- A. Manual Release Valve "O" Rings being Damaged on "Oildyne" Power Trim Pumps
- B. New Air-Bleeding Procedure for Power Trim Systems with "Oildyne" Pump
- C. 20 Amp Fuse on "Oildyne" Power Trim Pumps
- D. Individual Relief Valves for "Oildyne" Power Trim Pumps
- E. Malfunctioning Down Pressure Relief Valve on "Oildyne" Power Trim Pumps
- F. Troubleshooting "Oildyne" Power Trim Pumps

NUMBER: 83-34

Figure 1. Oildyne Power Trim Pump

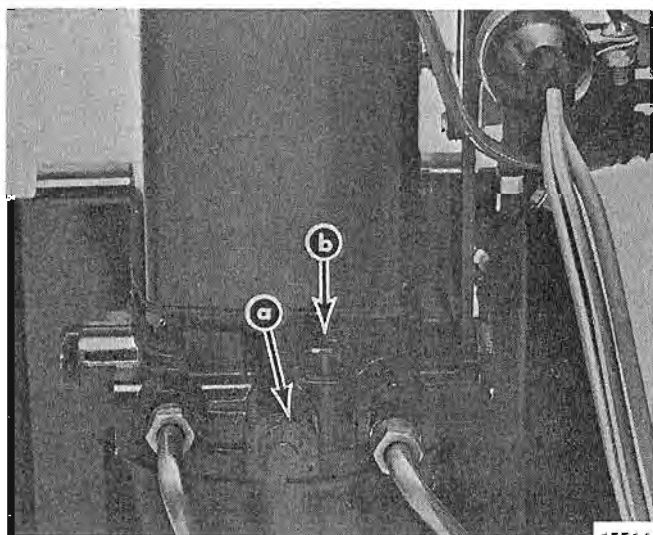
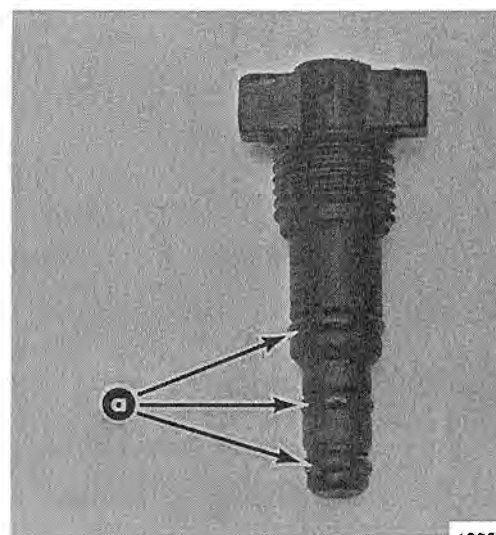
If you encounter a MerCruiser Stern Drive with an "Oildyne" Power Trim pump that has one of the problems listed below, the trouble may be due to damaged "O" rings on the "Manual Release Valve". (Figures 1 and 2)

- Drive unit leaks down from raised position.
- Drive unit cannot be trimmed "Out" or raised.
- Drive unit cannot be trimmed "In" or lowered.

Damage to the "O" rings may result from the following:

- Operation of the Power Trim pump with the "Manual Release Valve" partially open. **Valve Must Be Completely Closed (Turned Clockwise Until Bottomed-Out) When Trimming "IN" or "OUT"**. Tighten valve finger-tight only -- DO NOT USE A PLIERS.

- Opening "Manual Release Valve" quickly with stern drive unit in the fully raised position. **Valve Must Be Opened SLOWLY to Gradually Relieve Pressure On System.**
- Continuous use of "Manual Release Valve". **Valve Is Designed for Emergency (Limited) Use Only.**

**Figure 3. Bleeding "Up" Trim Circuit**

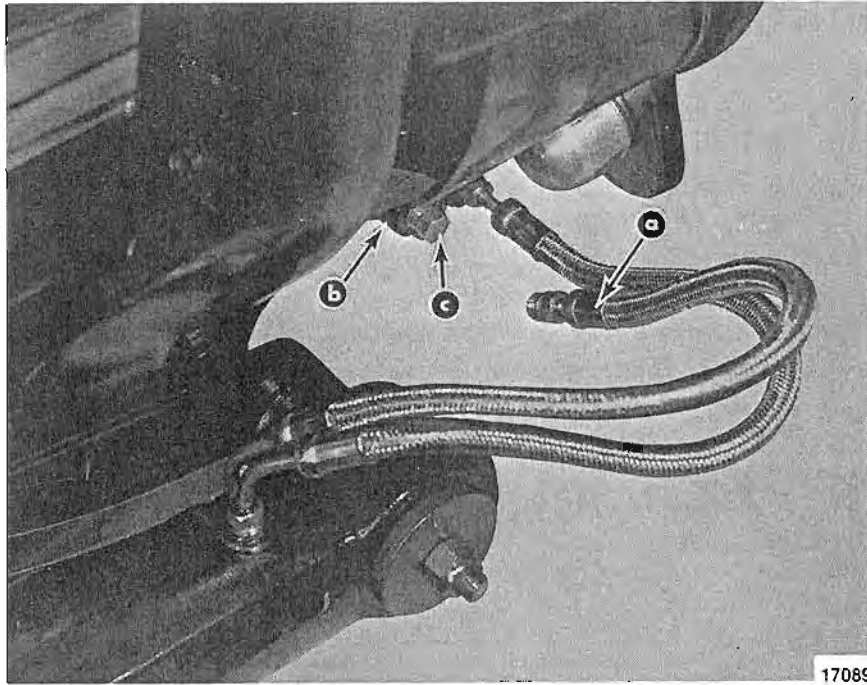
This procedure should be used instead of instructions outlined in MerCruiser Service Bulletin 83-13. Procedure has been changed to prevent possible damage to "Manual Release Valve" "O" rings and to ensure more complete bleeding of system.

2. Make sure that "Manual Release Valve" (Figure 1) is completely closed (bottomed-out).
3. Disconnect "Up" hose from front connection on rebuilt trim cylinder. (Figure 3) If both cylinders were rebuilt, disconnect hose from both cylinders.
4. Direct end of trim hose(s) into a container; then, run trim pump in the "Out" ("Up") direction until a solid, air-free stream of oil is expelled from hose(s). Reconnect hose(s) and tighten securely.
5. Refill trim pump to proper level.
6. Disconnect "Down" trim hose (on side with rebuilt trim cylinder) from rear connection on gimbal housing hydraulic connector. (Figure 4) If both cylinders were rebuilt, disconnect hose from aft connection on both sides of connector.
7. Plug connector(s) in hydraulic connector, using plug (22-38609) or a suitable device. (Figure 4)

**Figure 5. 20 Amp Fuse On "Oildyne" Pump**

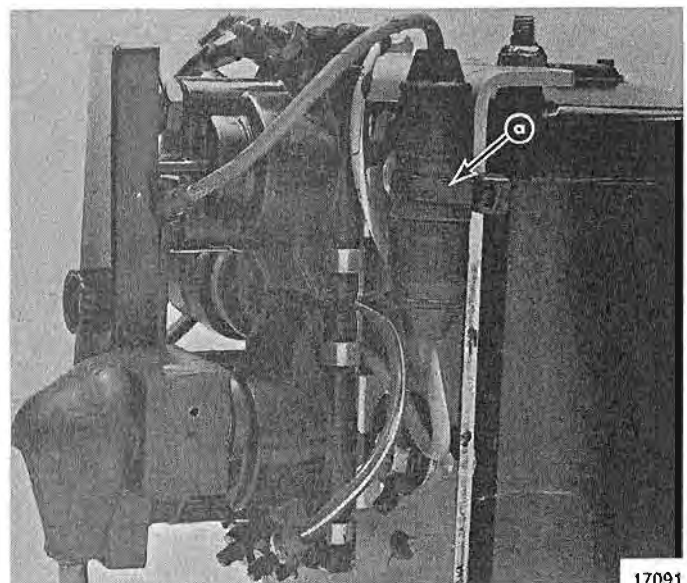
Newer production "Oildyne" trim pumps are equipped with a 20 amp fuse instead of a circuit breaker (Figure 5). The part number for the replacement fuse is 88-79091. This fuse protects the trim control and wiring harness.

**Figure 6. "Oildyne" Power Trim Pump Relief Valve**

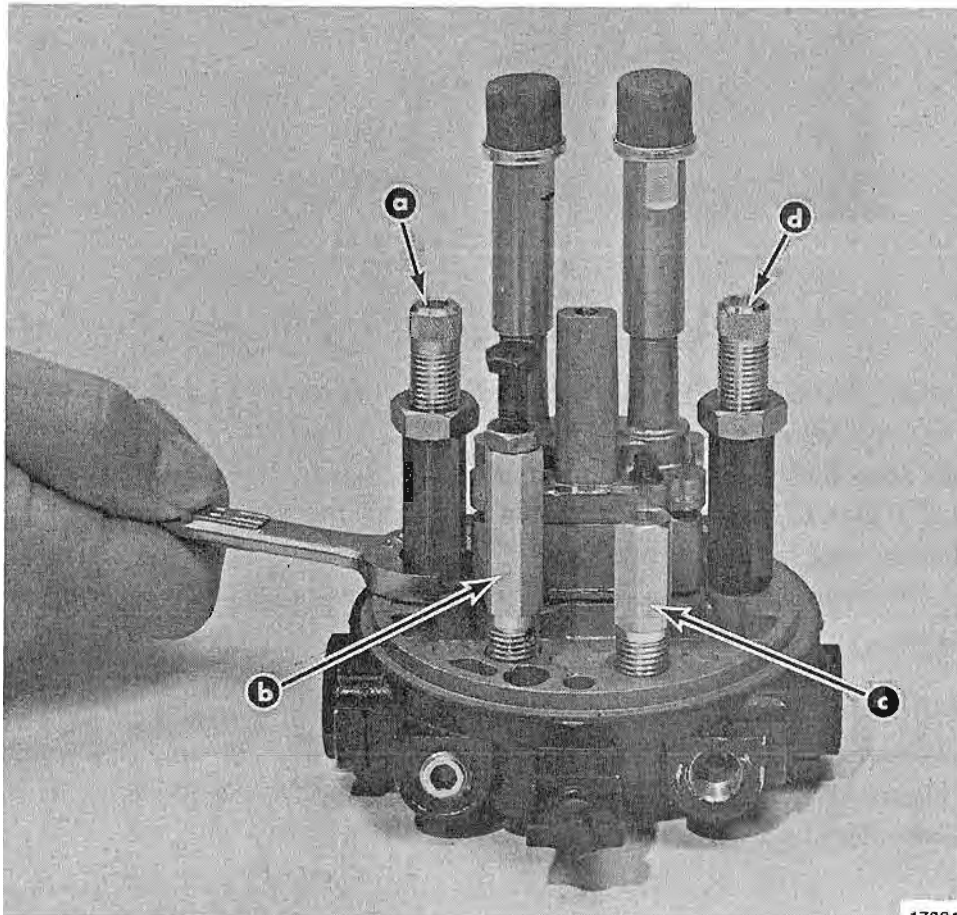
Individual relief valves for the "Oildyne" Power Trim pump are now available under the part numbers listed below. (Figure 6) Installation instructions are included with each valve.

*NOTE: Early production "Oildyne" pumps were equipped with a trail-out valve. This valve was eliminated on later pumps. If this valve should fail on one of the early production pumps, the valve can be removed and replaced with plug (19-11005).*

If you encounter a MerCruiser Stern Drive (with an "Oildyne" trim pump) where the pump motor runs, but the drive unit will not lower from the raised position, the problem may be due to a malfunctioning down pressure relief valve. (Figure 6) To correct this problem, install a new down pressure relief valve (95355A1). This valve is of a new design for improved reliability.

The new valve is being used on all current production Power Trim pumps and replacement parts.
